## SITE PLAN REVIEW AND APPEARANCE BOARD

File No.: 2019-148-SPF-SPR-CLIV

Application Name: Buddha Skybar

### Item before the Board:

SP.1  
SHEET NO.

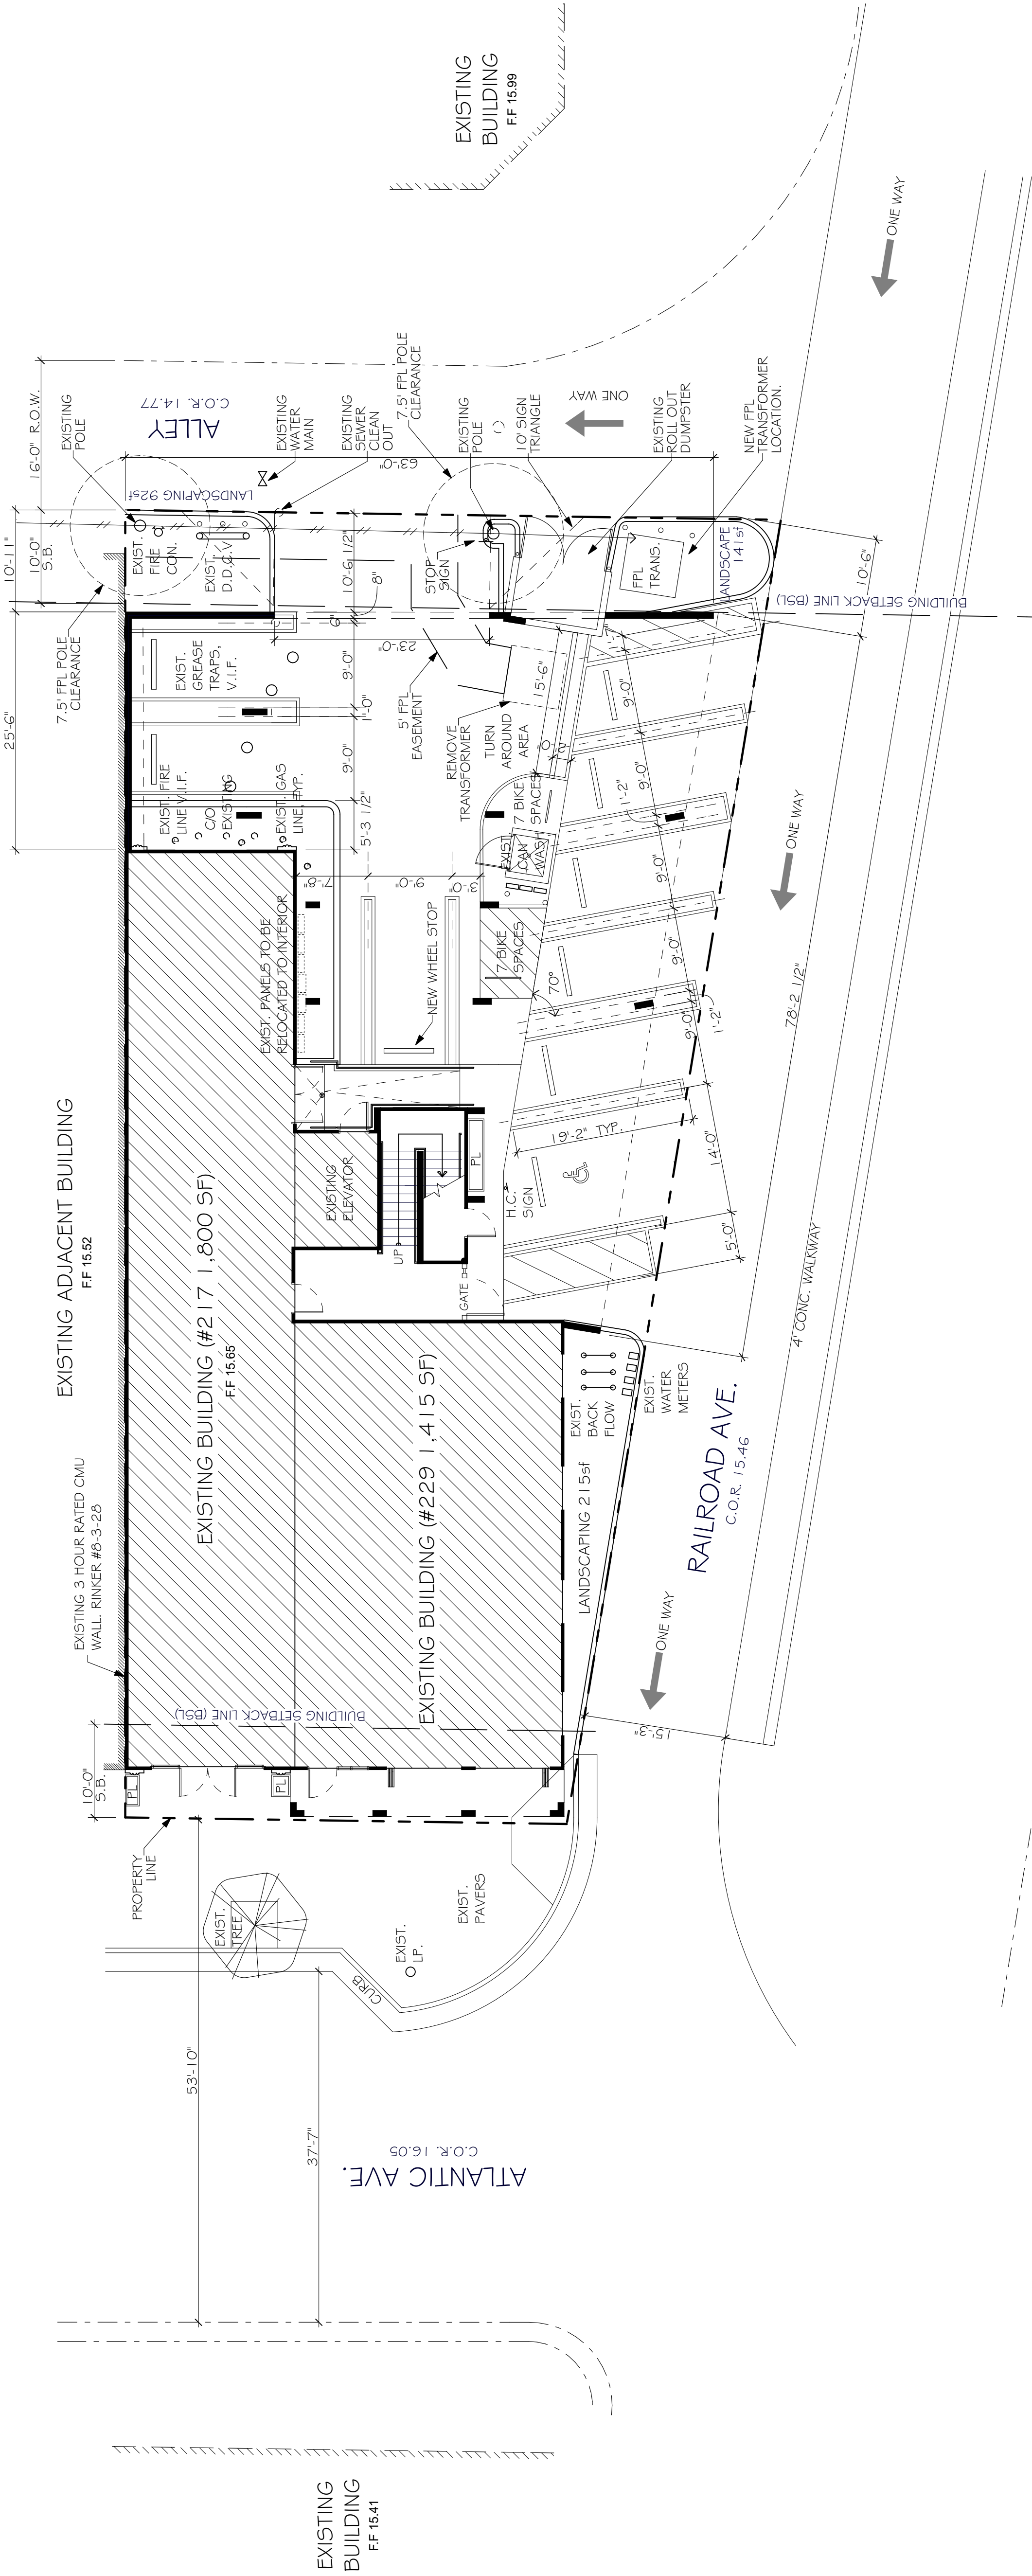
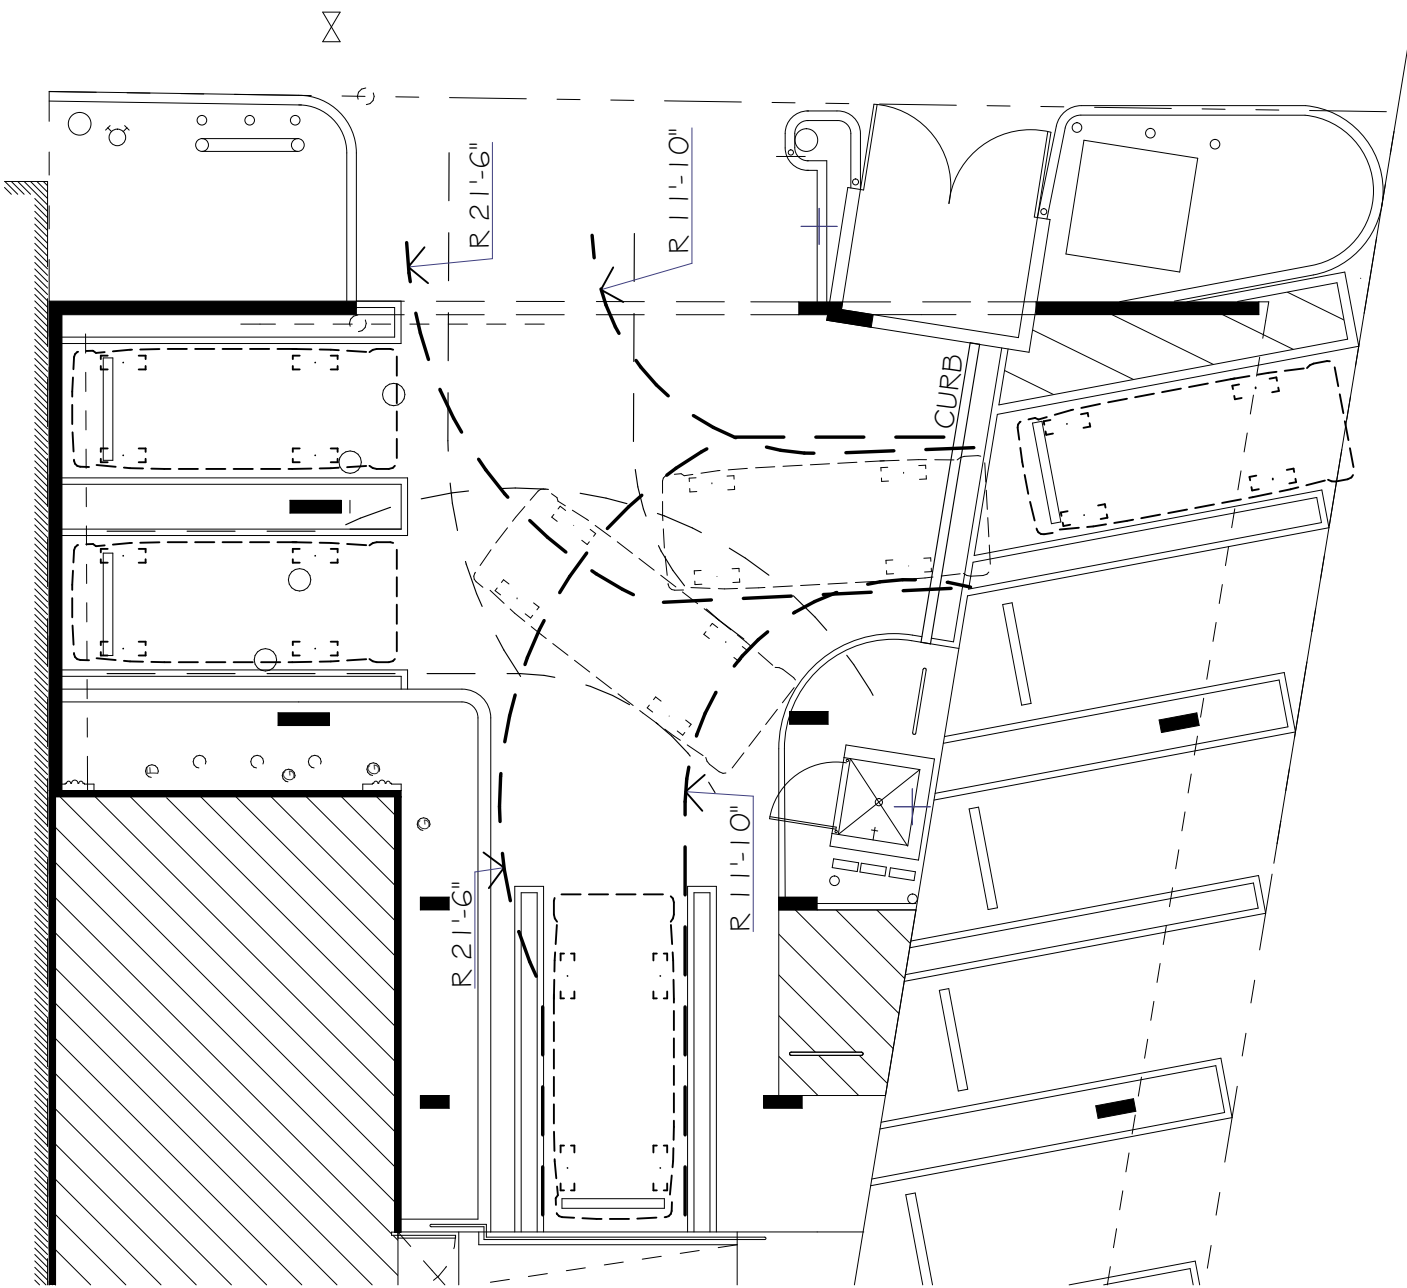
- Site Plan SP.1 shows a proposed lateral connection into an existing water main along the rear alley way.
- Site Plan SP.1 shows a proposed lateral connection into an existing sanitary sewer main along rear alley way.
- Pursuant to the City’s Comprehensive Plan, treatment capacity is available at the City’s Water Treatment Plant and the South-Central County Wastewater Treatment Plant for the City at build-out. Based upon the above, positive findings can be made with respect to this level of service standard.

A1.10  
SHEET NO.

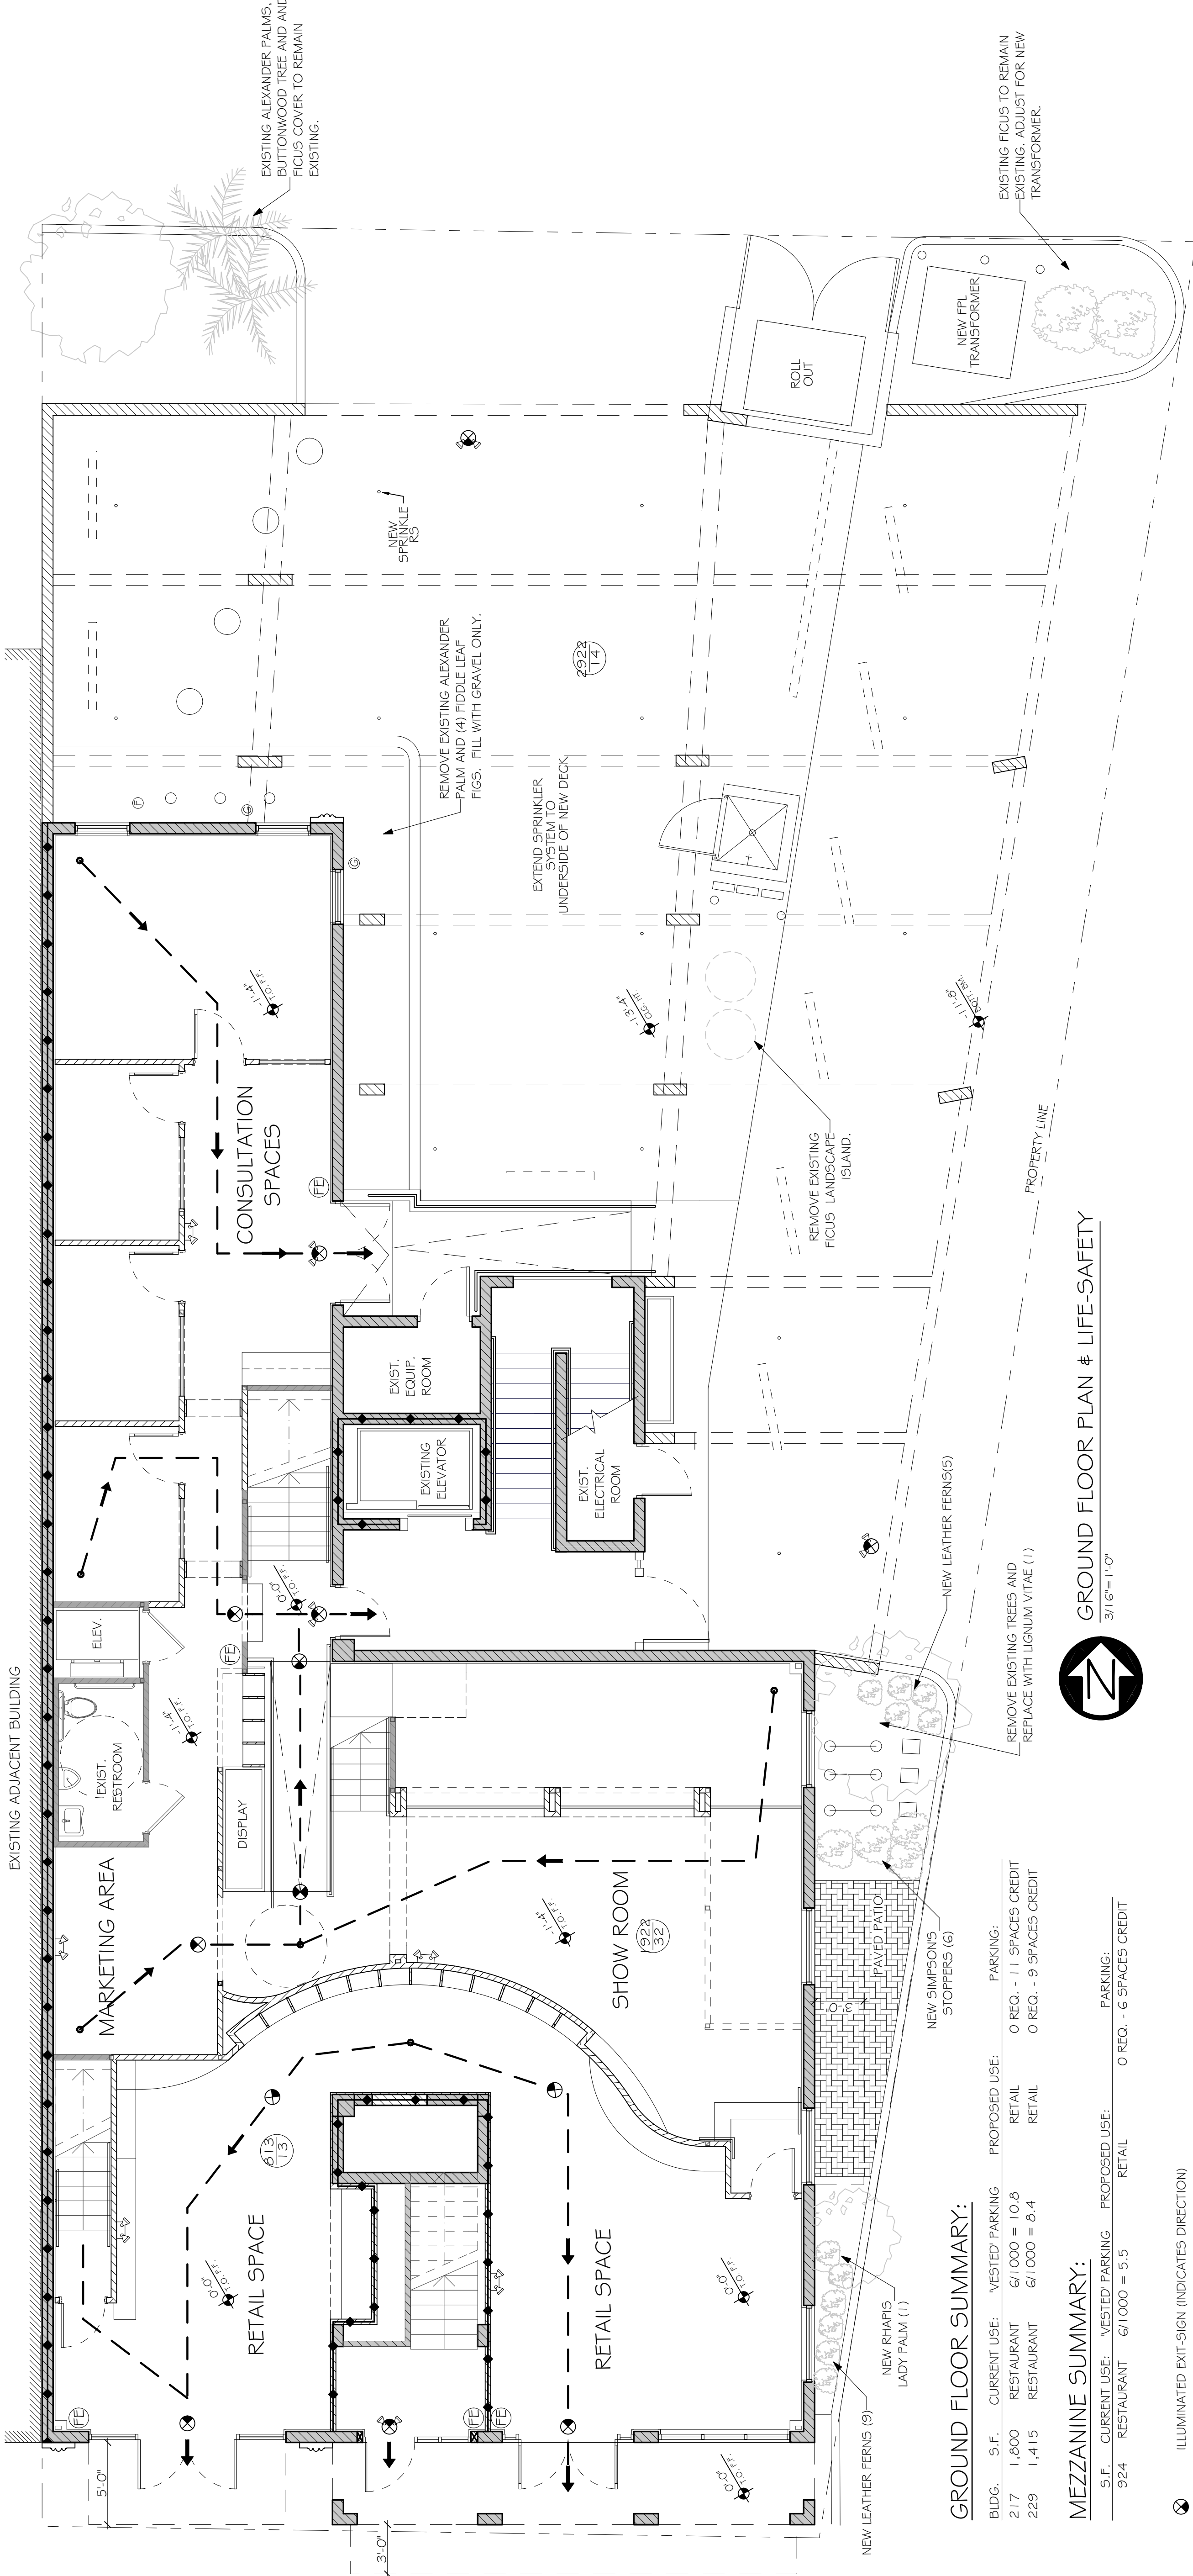
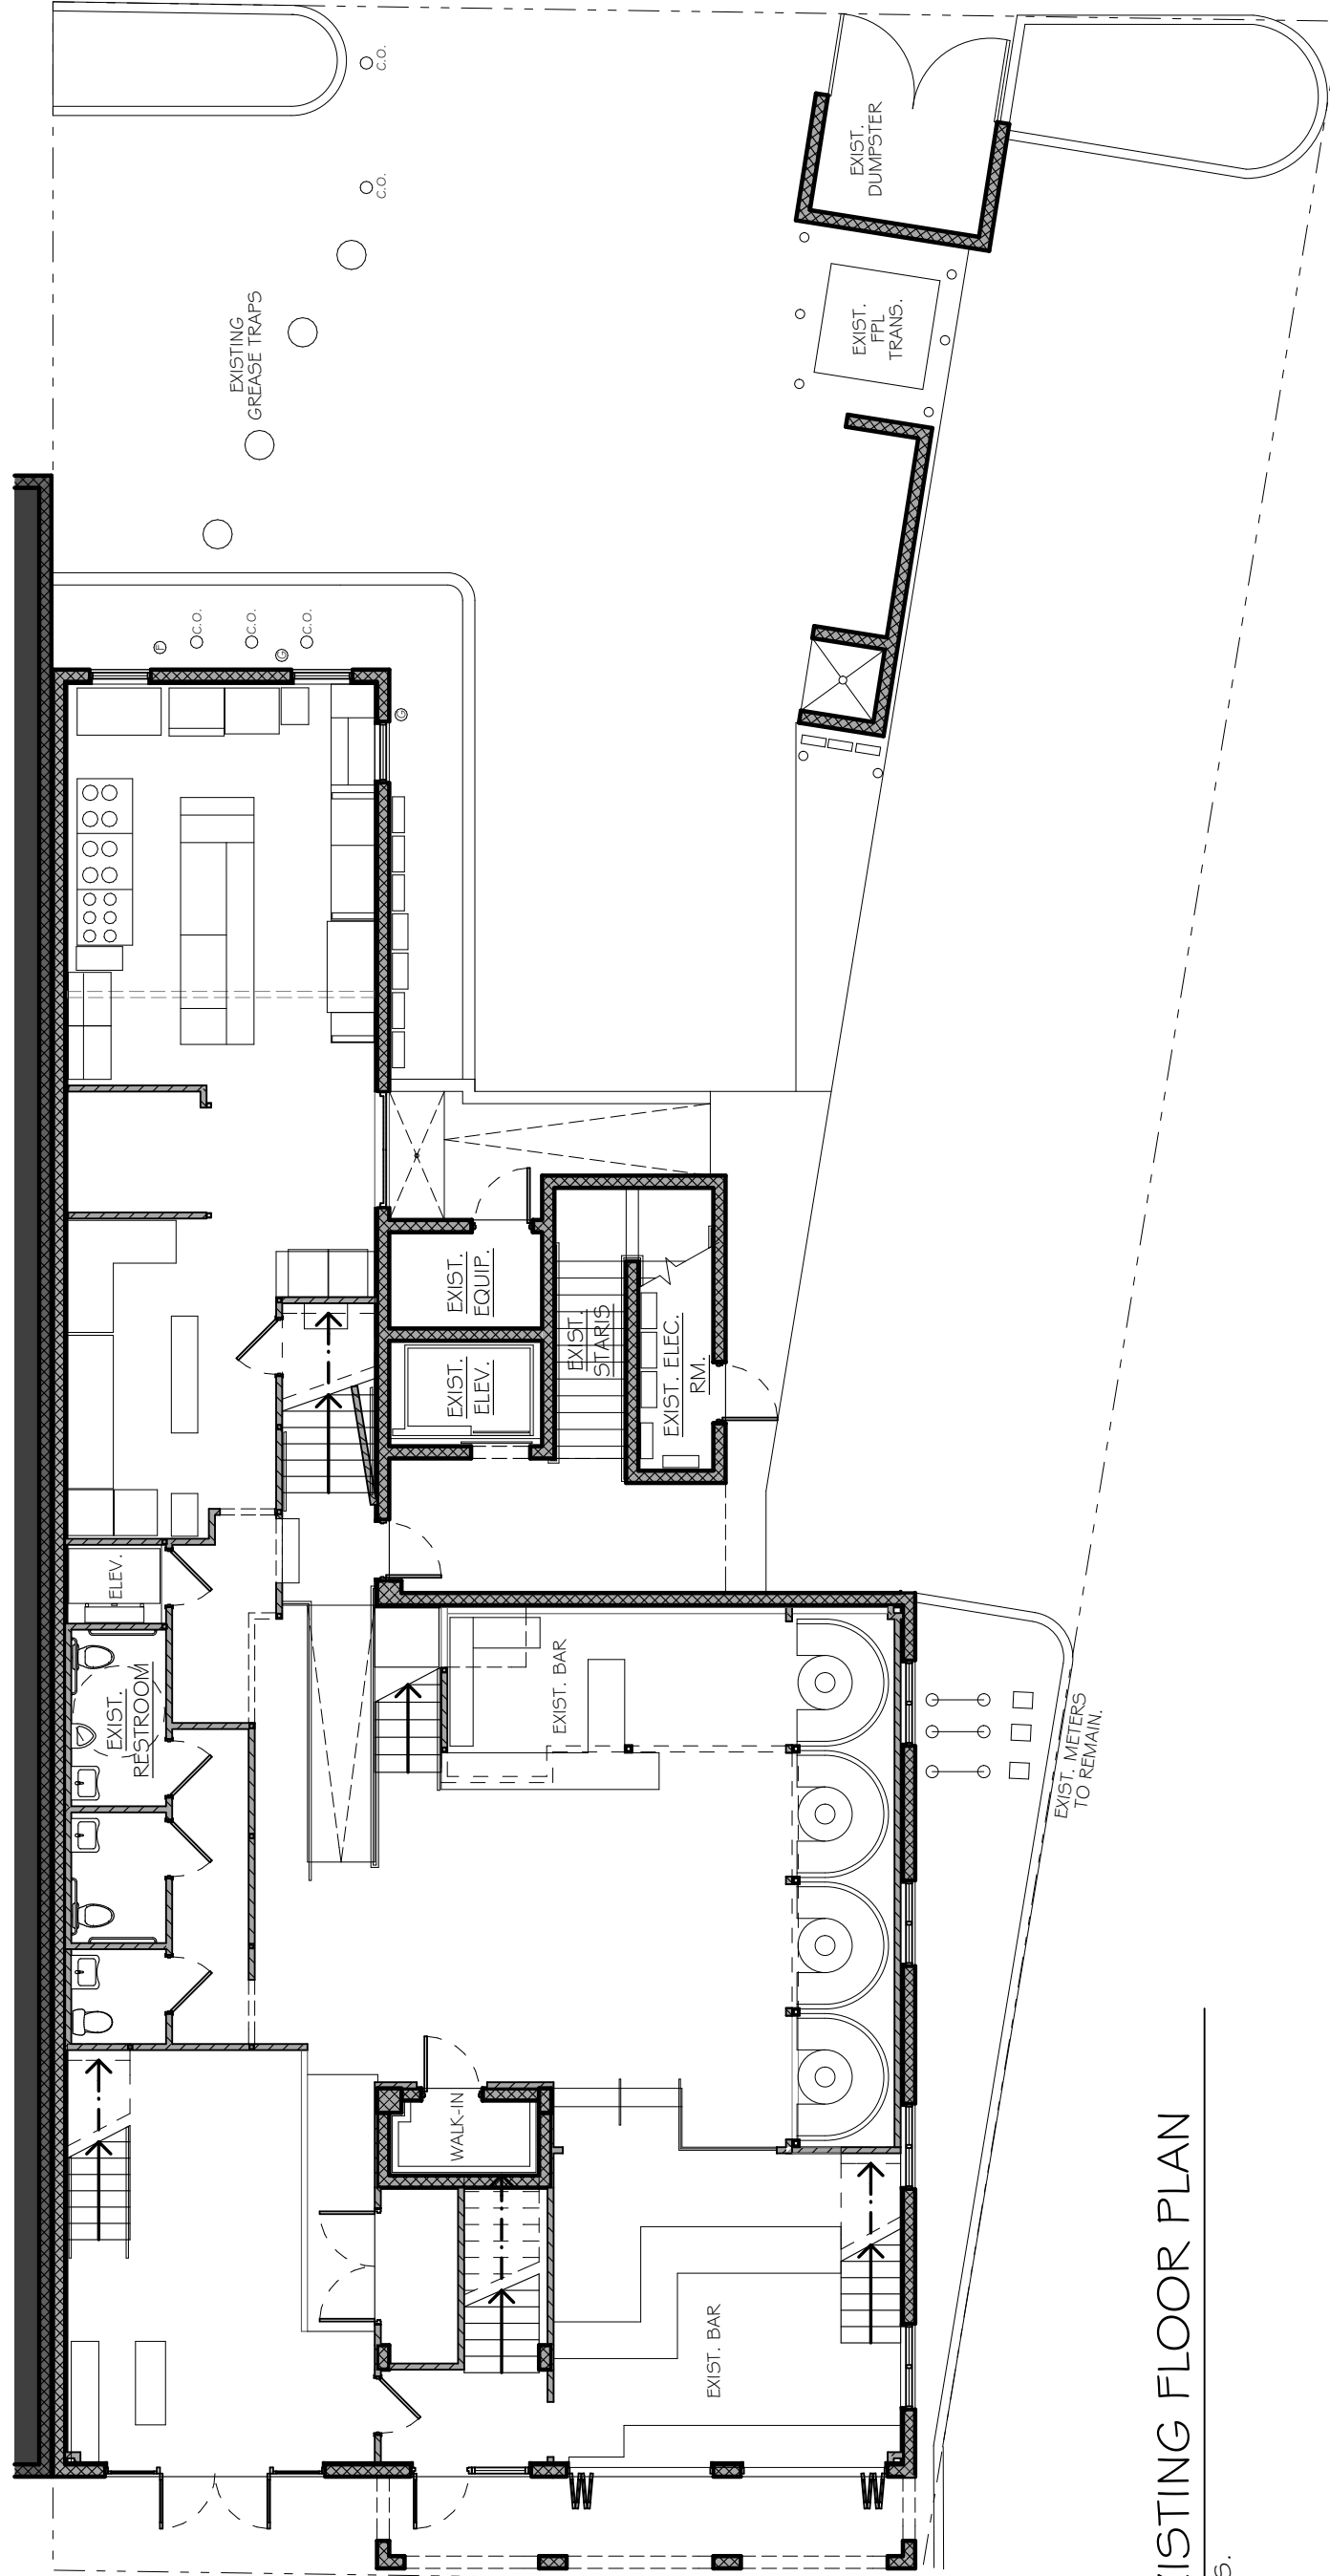
- Plan pages A1.10 and A1.2, show minor landscape improvements consisting of the removing and replacing of existing plants and trees on site. The landscape modifications have been reviewed by the City's Senior

Landscape Planner for compliance with the LDR. Plan page A1.10, shows new leather fern, phapis palms, and simpson stopper plants replacing the existing landscaping at the east side of the building adjacent to railroad. The plans show the removal of existing trees interior to the parking lot where the proposed outdoor deck will be located. Lastly, in accordance with LDR section 4.4.13 (E)(2)(b)1., *street trees shall be provided for all existing buildings that are proposing to exceed 20% gross square footage*. Furthermore, for those properties where street trees exist at the time of site plan approval, street trees can be provided in another location on-site, or an equivalent contribution can be paid into the Tree Trust Fund. As such, note has been added to this report requiring that additional streets trees be provided in an alternative location on site, or the equivalent monetary donation be contributed to the City's "Tree Trust Fund" in the amount of \$1,000. Thus a positive finding can be made in regard to this regulation.
